Access Compliance Report

Public Rights-of-Way

(Curb Ramps)

Intersection ID: 25263	Main Street: CARPENTER_DR	Cross Street: SHADOWLAKE_DR	Location: S
ADA ID: 3ABBEBC97347	Ramp Type: PerpDiag	Initial Pass/Fail: Fail	Overall Compliance: No
Severity Score: 25			
Codes/Mitigation Info/Possible Solution		Field Measurements/Component Compliance

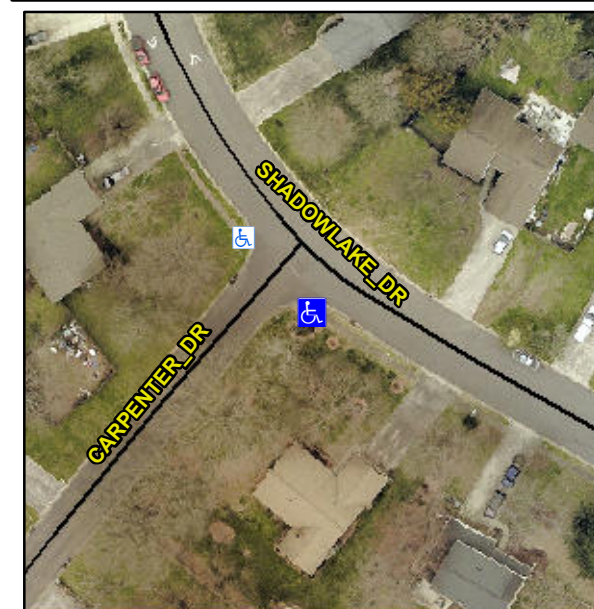
Not Found, R304.2.2

Compliance	Description	Data	Compliance	Description	Data
N/A	Ramp Length (in)	34.0	No	Ramp Slope (%)	13.8
Yes	Ramp Width (in)	48.0	Yes	Ramp XSlope (%)	1.3
N/A	Flare Type LT	N/A	N/A	Flare Type RT	N/A
N/A	Flare Slope LT (%)	N/A	N/A	Flare Slope RT (%)	N/A
N/A	Flare Traversable LT?	N/A	N/A	Flare Traversable RT?	N/A
N/A	Landing Length (in)	N/A	N/A	DWS Provided?	N/A
N/A	Landing Width (in)	N/A	N/A	DWS Contrast?	N/A
N/A	Landing Slope (%)	N/A	N/A	DWS Length (in)	N/A
N/A	Landing X Slope (%)	N/A	N/A	DWS Full Width?	N/A
N/A	Landing Curb? (Y/N)	N/A	N/A	DWS Offset (in)	N/A
N/A	Shared Landing?	N/A			
N/A	Gutter Ponding?	N/A	N/A	Gutter Slope (%)	N/A
N/A	Gutter Lip Ht (in)	N/A	N/A	Gutter X Slope (%)	N/A
N/A	Painted X Walk1?	No	N/A	Painted X Walk2?	No
	X Walk 1 Direction	To NE		X Walk 2 Direction	To NW
N/A	X Walk 1 Width (in)	N/A	N/A	X Walk 2 Width (in)	N/A
	X Walk 1 Slope (%)	7.5		X Walk 2 Slope (%)	4.0
	X Walk 1 X Slope (%)	3.6		X Walk 2 X Slope (%)	7.8

Remove & Replace Curb Ramp With Two New Directional Ramps or Equivalent.
